City of Sidney, MT
Park and Recreation Committee Meeting 1-24-24
January 24, 2024 5:30 PM
115 2nd Street SE | Sidney, MT 59270

RE: Sidney Tiger Sharks
Svarre Municipal Pool Permanent Bulkhead
Engineering Commentary from 8-29-23 Meeting
ie# WR22-04-097

Sidney Bulkhead Structure Analysis

Assumed Soil Properties

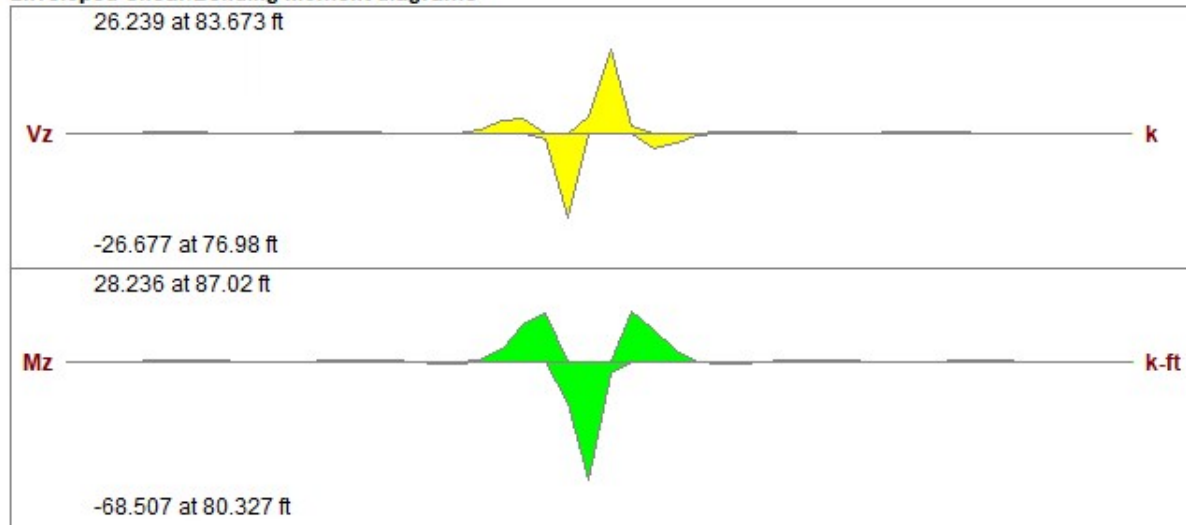
a. Can a structural analysis be performed on the permanent design with the existing slab and subgrade ahead of a council decision?

$$k := 50 \text{ pci} = 86400 \text{ pcf}$$

Subgrade Modulus[k/ft ³]	Allowable Bearing[ksf]
86.4	1.5

- Based on the above assumptions and calculations, the existing floor slab of the pool is structurally adequate to support the bulkhead structure and associated loading.

2. Shear and Bending Analysis

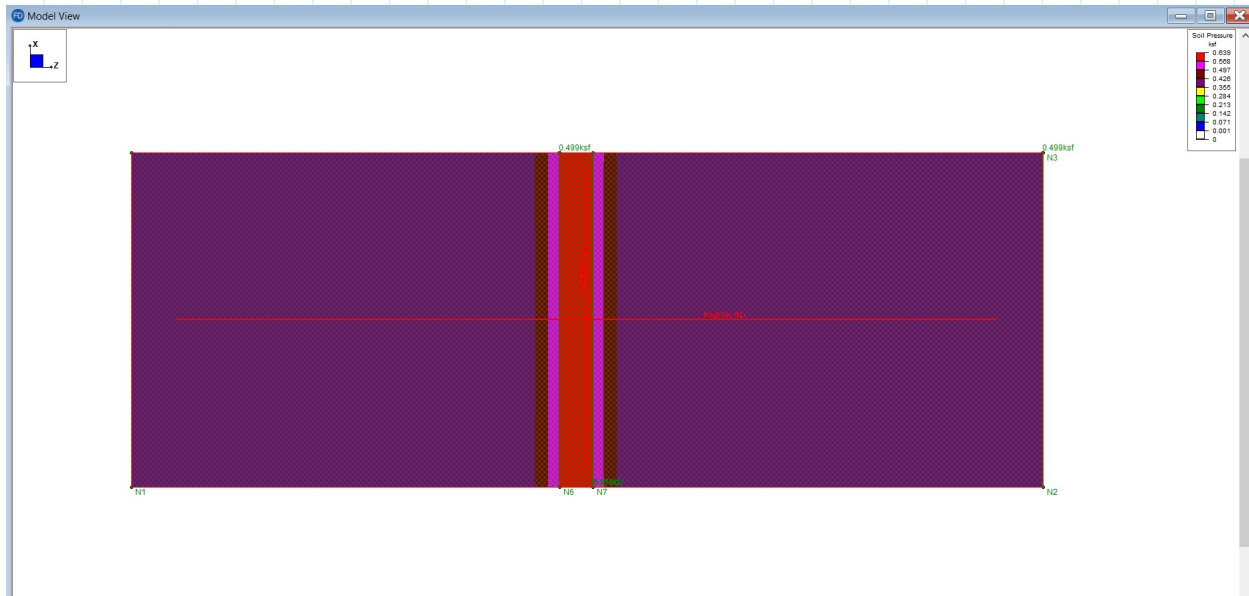
2. The Committee has concerns with the weight of the permanent Bulkhead.

ACI 318-19 Code Check

Top Bending Check	0.141	Bot Bending Check	0.341	1 Way Shear Check	0.167
Gov Mu Top	28.236 k-ft	Gov Mu Bot	-68.507 k-ft	Gov Vu	26.677 k
phi*Mn Top	200.759 k-ft	phi*Mn Bot	200.759 k-ft	phi*Vn	159.461 k
Governing Cut	DS1-X27	Governing Cut	DS1-X25	Governing Cut	DS1-X24
Governing LC	2	Governing LC	2	Governing LC	2
Tension Bar Fy	60 ksi	Concrete Weight	0.145 k/ft^3		
Shear Bar Fy	60 ksi	λ	1		
F'c	4 ksi	E_Concrete	3644 ksi		
Flex. Rebar Set	ASTM A615	Rho Mid Prvd	0.00736		
		Prvd Mid Bar Spac.	#4@9in

POOL CROSS SECTION
1/4" = 1'-0"

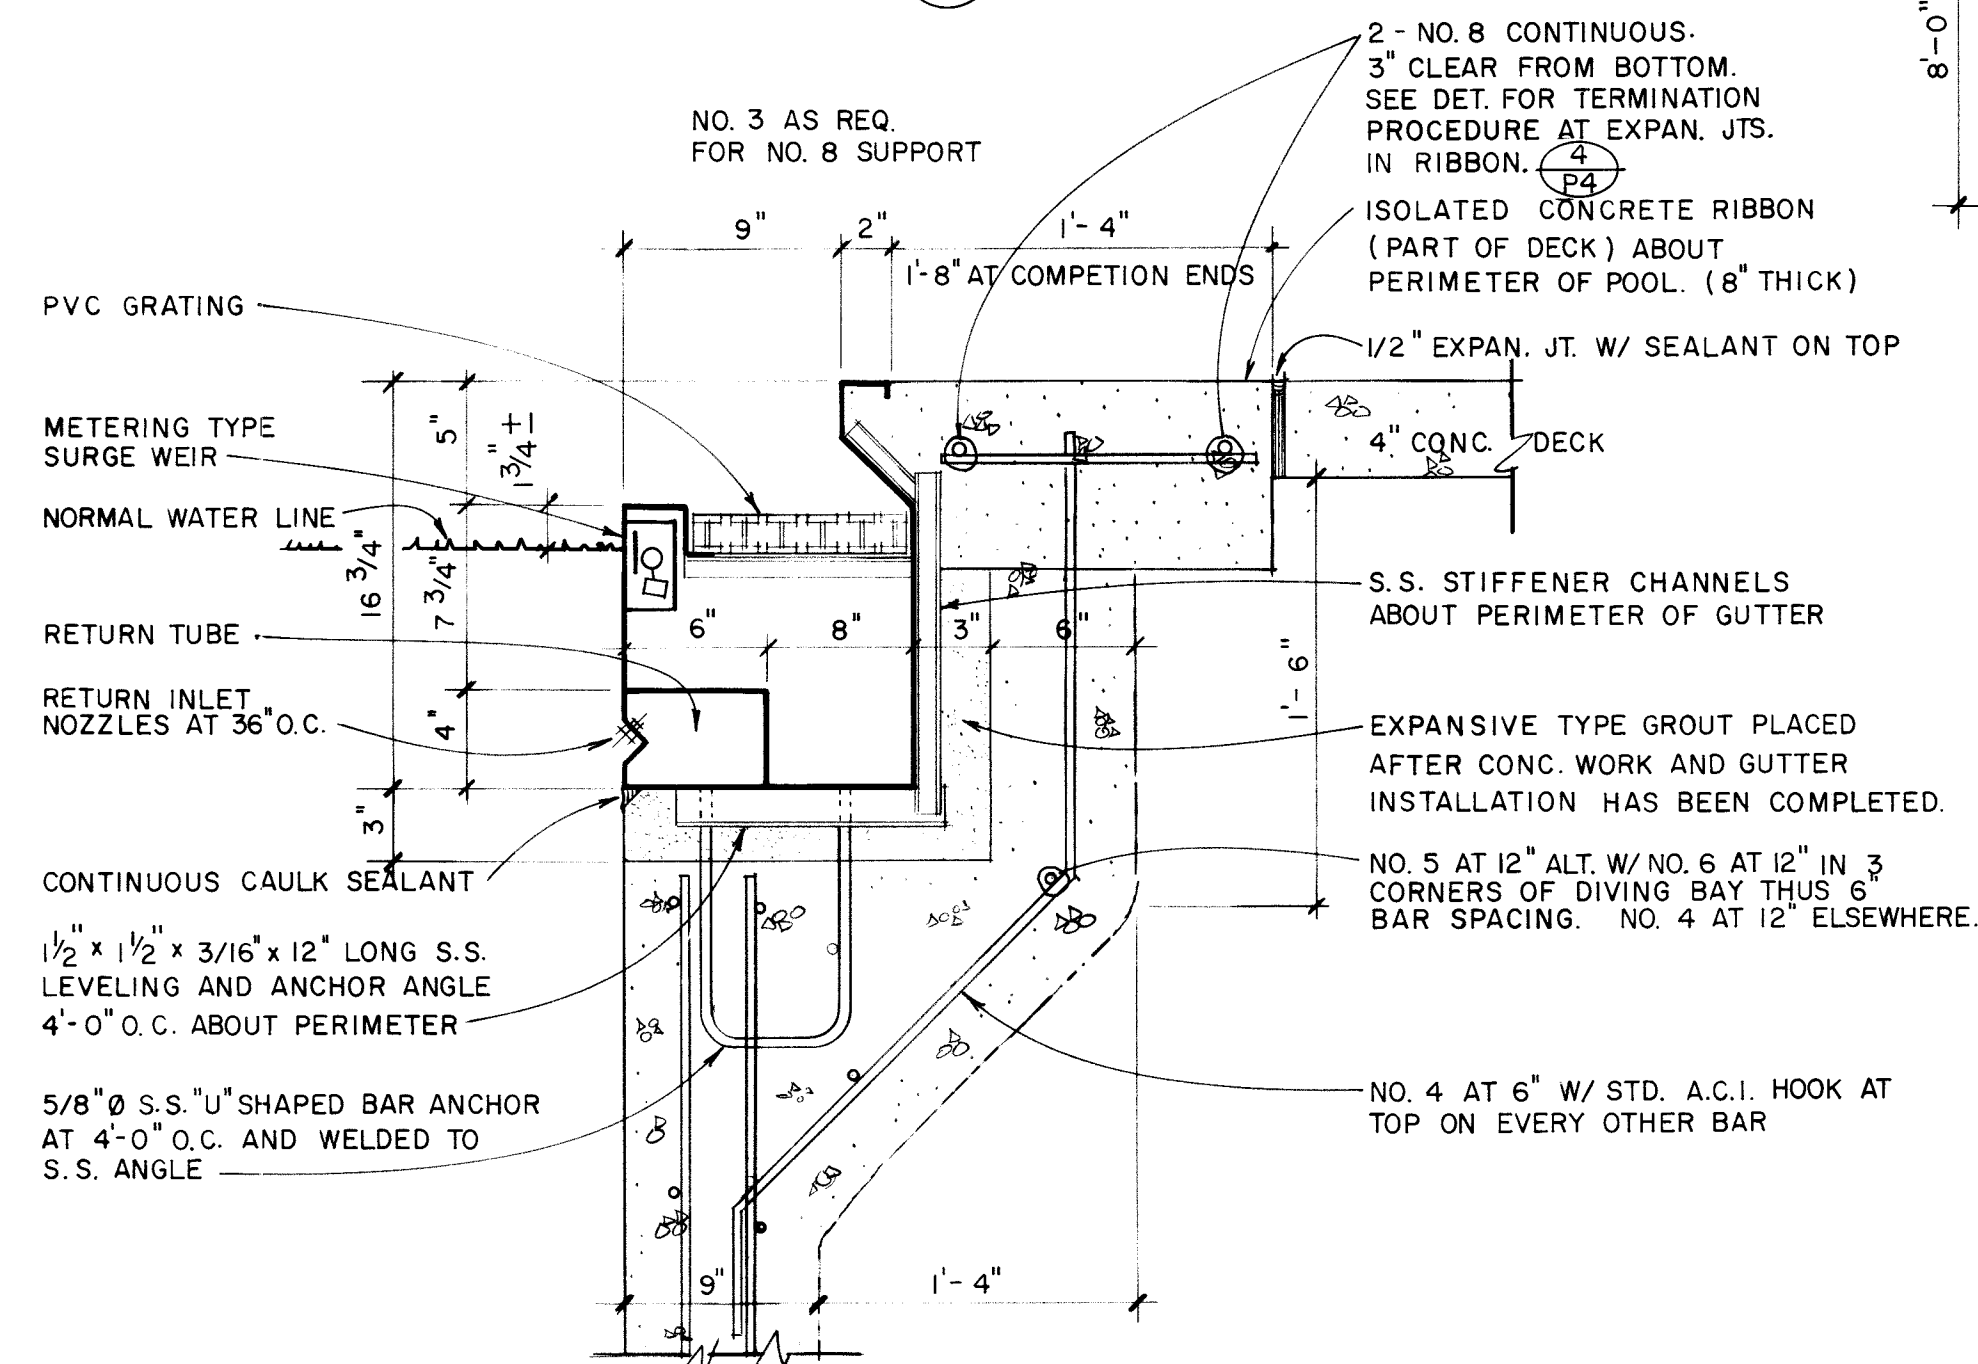
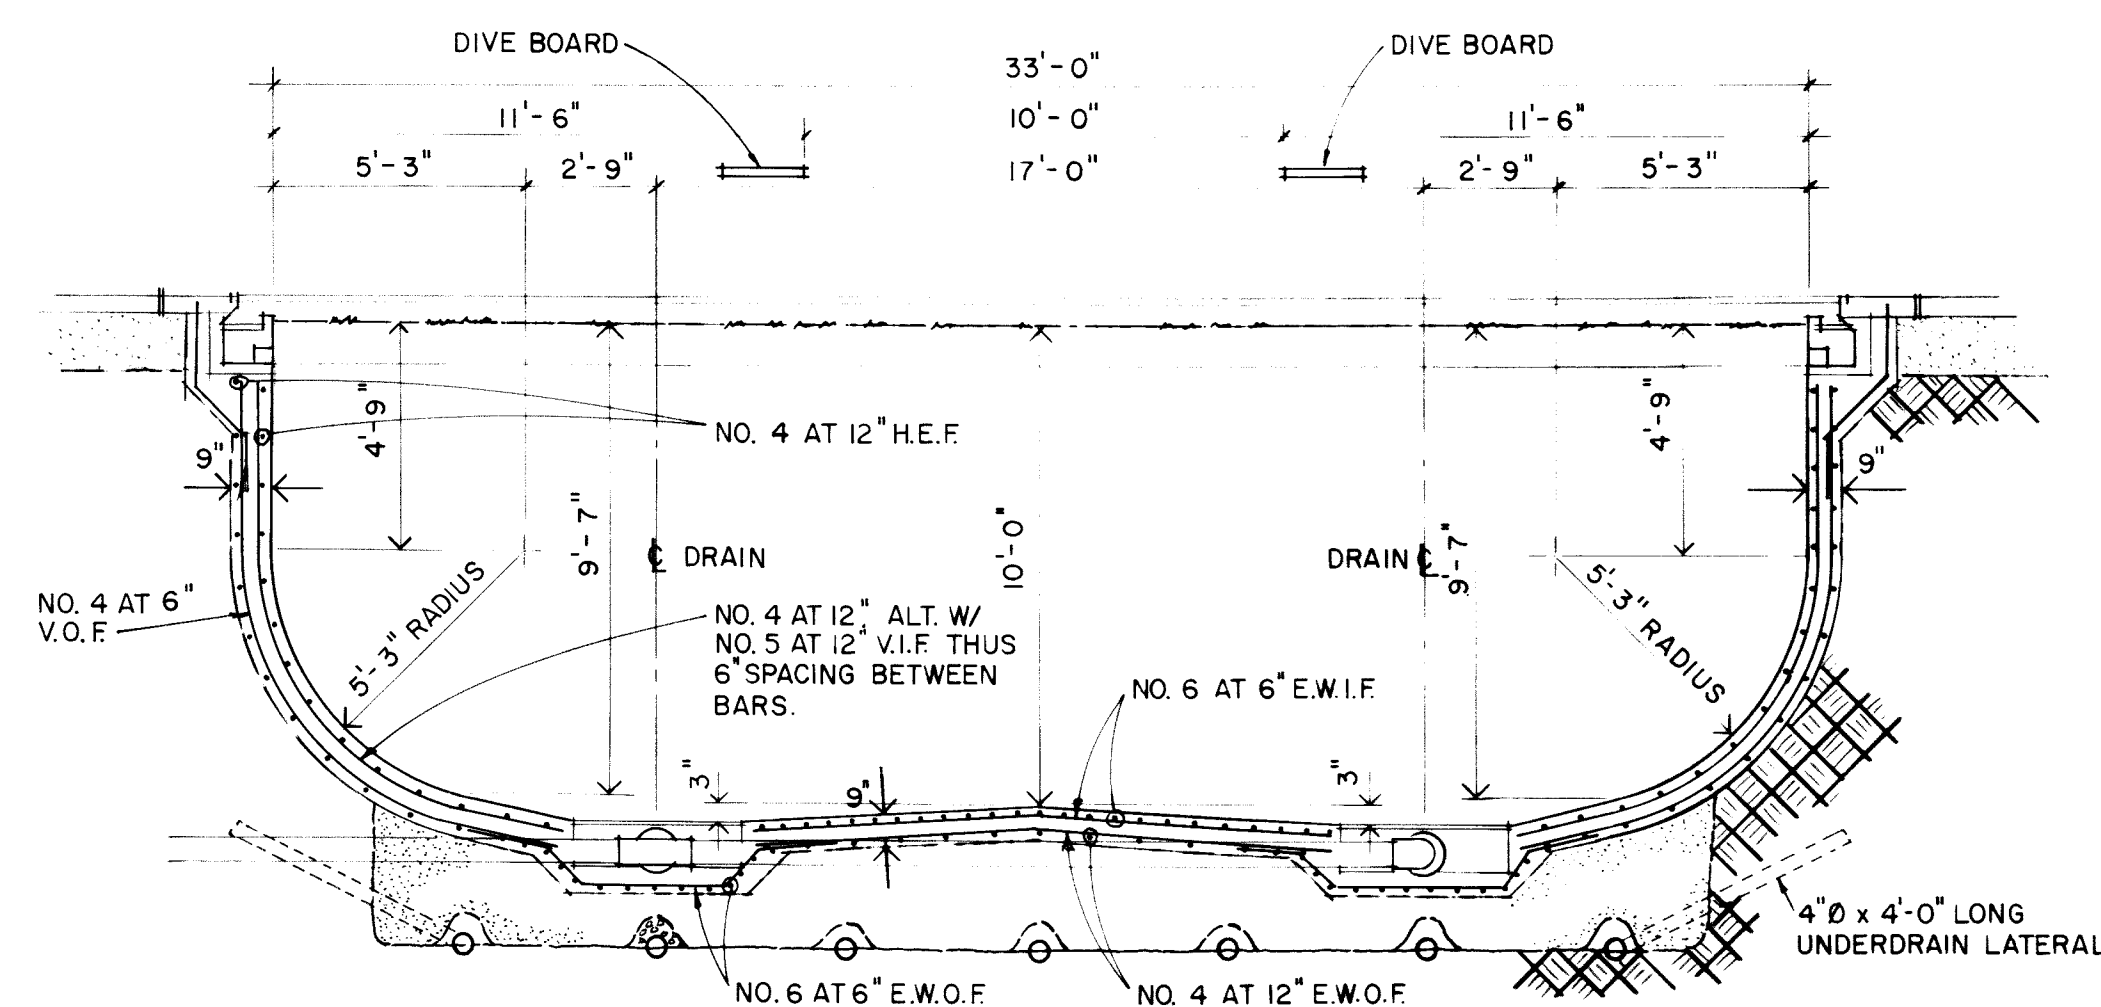
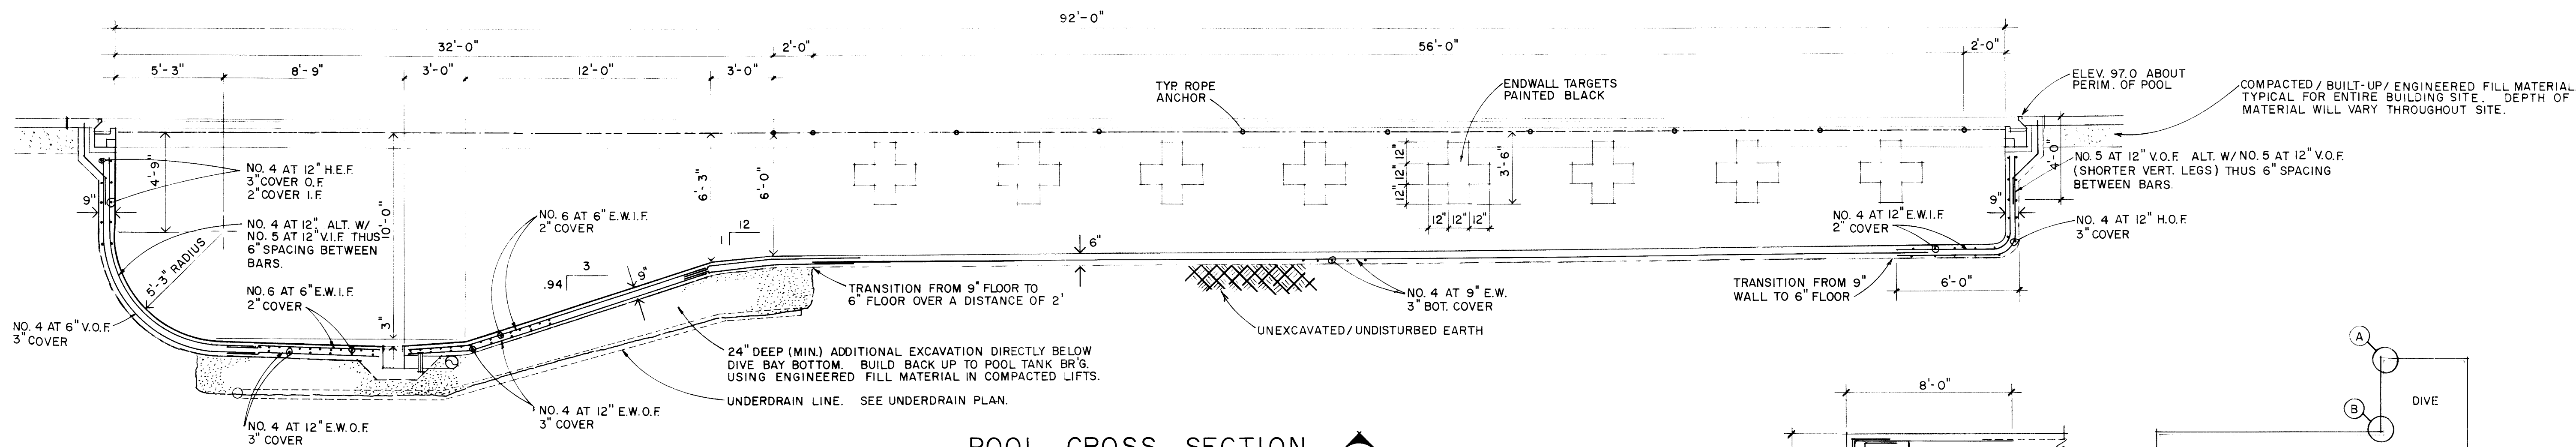
c. Is there a chance that any gravel under the slab is gone now?

The pool floor was constructed on unexcavated/undisturbed earth. Refer to Pool Cross Section 1/P3 within Attachment #5.

There is no piping under the pool floor that could have broken and cavitated the slab.
